# Memorandum

**Re:** Petitions PLNHLC2014-000730 & PLNHLC2014-00628  
New Single-Family Home at approximately 757 N. Wall Street

### New Single Family Dwelling New Construction PLNHLC2014-00730 and PLNHLC2014-00628 757 North Wall Street

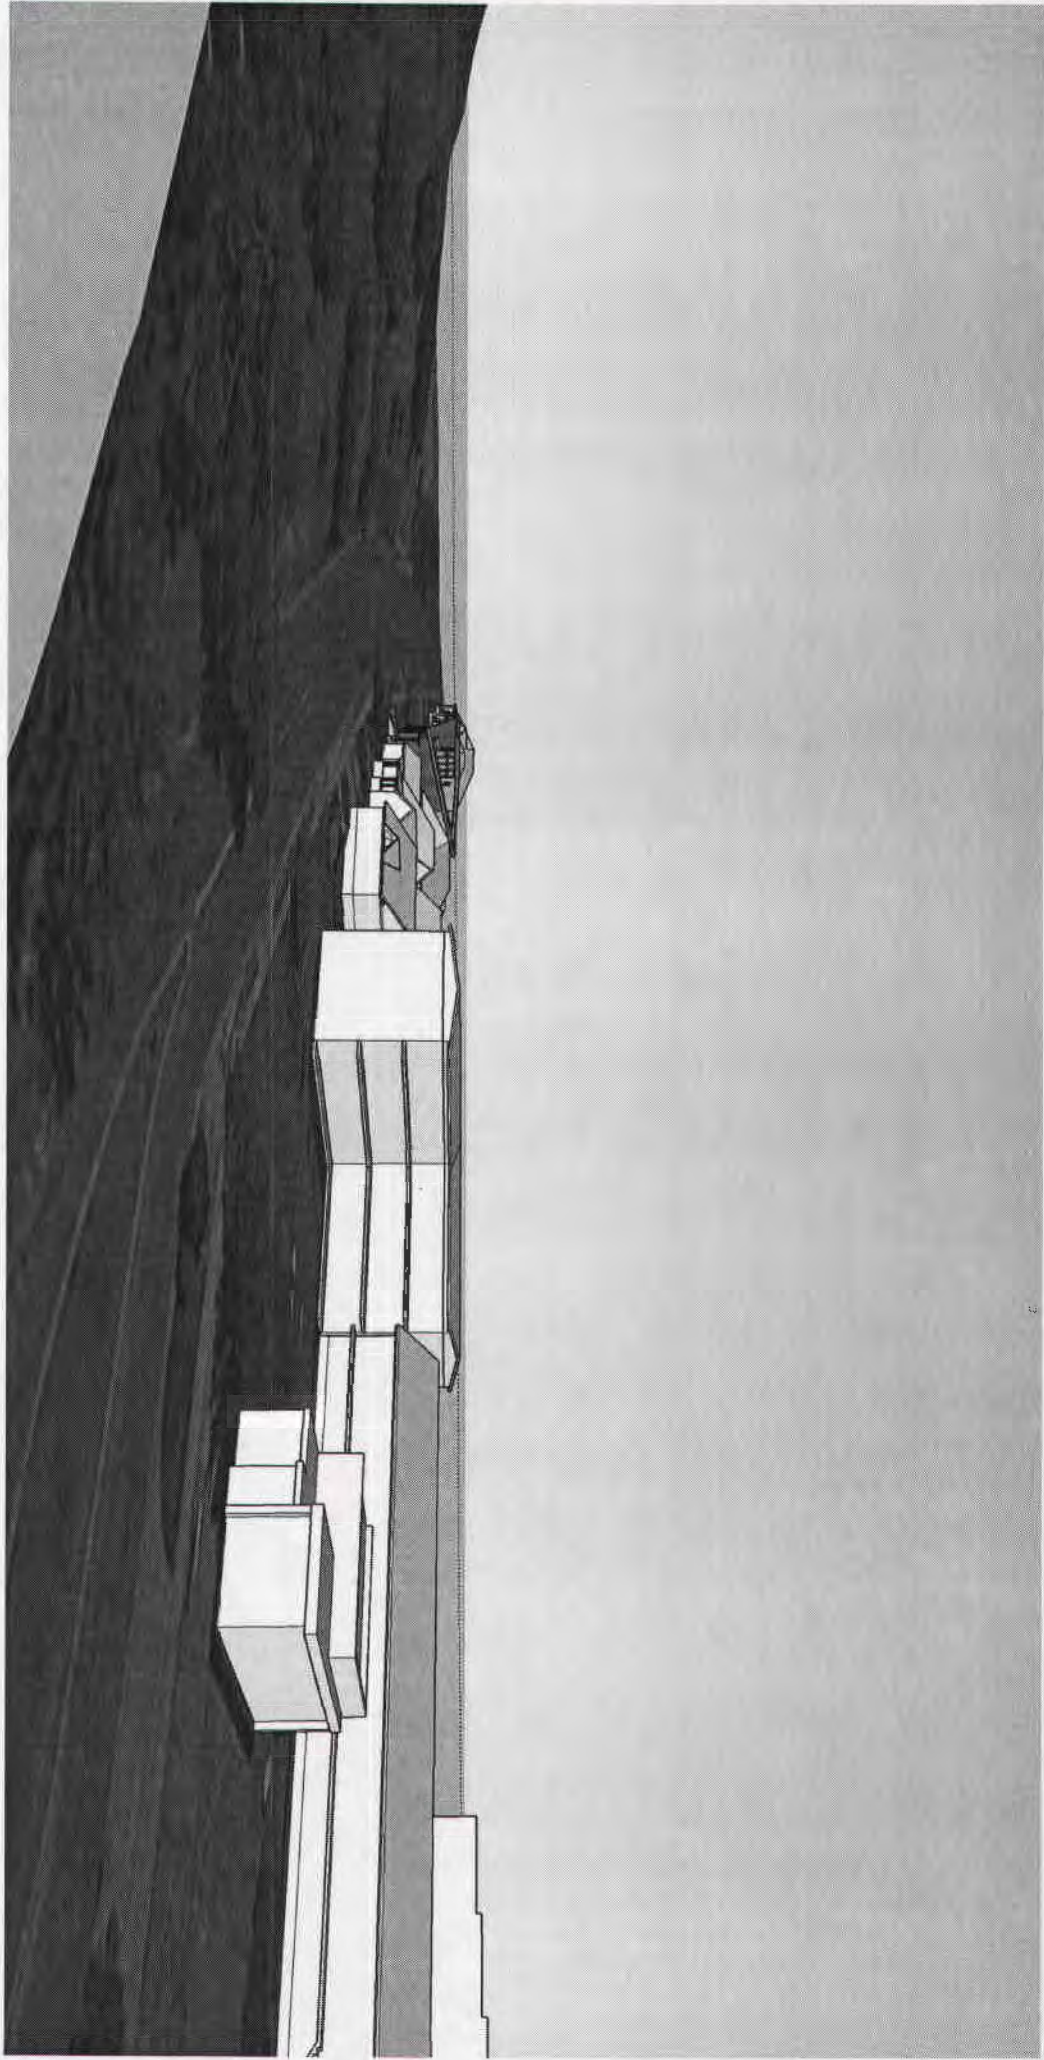
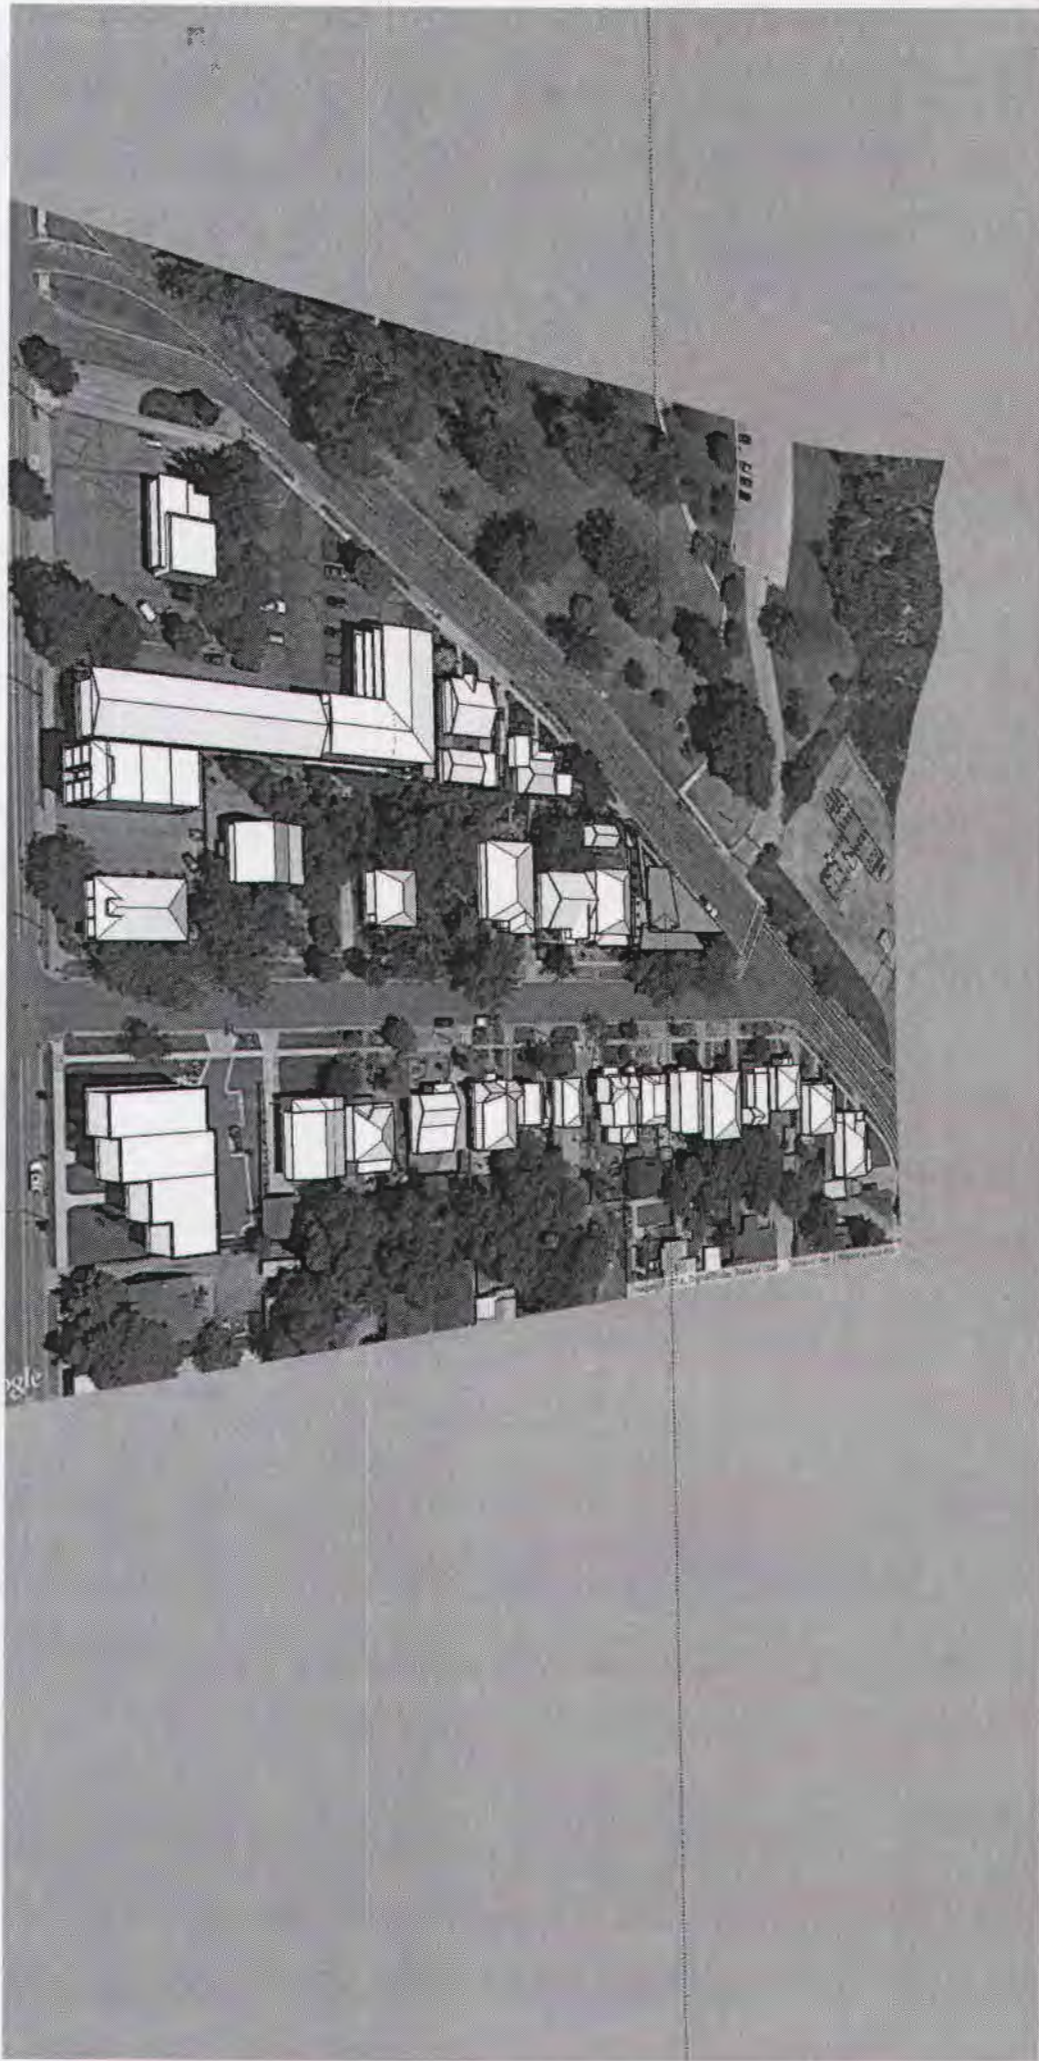
1. The proposed residence is out of scale with the neighborhood; it's too large.

2. The proposed residence is in excess of the maximum lot coverage.

3. The proposed residence should embrace both Wall Street AND Reed Avenue.

4. Shorten the total length of the facade along Wall Street.

5. The proposed residence is too tall.

Applicant response - Due to the allowance of tandem parking, we were able to reduce the footprint of the home from approximately 2,300 square feet to 1,438 square feet and still provide the required 2-car parking: the garage is approximately 327 square feet for a total footprint of 1,765 square feet, a 23% reduction.

Applicant response - The new design represents a 10% reduction in lot coverage. If we calculate the area of the lot sidewalk to sidewalk, the lot coverage drops from 45% to under the 40% maximum requirement at 35% lot coverage. However, due to the unusual property lines, we are still requesting an exception for lot coverage, which is now 53% calculated by actual lot size (down from 63%).

Applicant response - We have embraced Reed Avenue by accentuating the sidewalk approach to the front door and have expanded the courtyard at the southwest corner of the home along the street. The enlarged courtyard becomes more welcoming and inviting. In addition, we believe that the roof-line on Reed Avenue successfully embraces the porch elements found throughout the neighborhood.

Applicant response - By eliminating the attached 2-car garage, we were able to shorten the overall length of the home on Wall Street by over 20 feet. In addition, the enclosed garage is set back from the sidewalk by 25-30 feet, which greatly softens the facade along Wall Street. Our re-design initially proposed a detached garage. However, the garage has been attached to the home, allowing for the required 4' side yard set-back. The garage/west wall is a full 10' from the neighboring home.

Applicant response - Due to the new garage design, we have eliminated the need for a height exception, as the home no longer extends into the southwest corner of the lot.
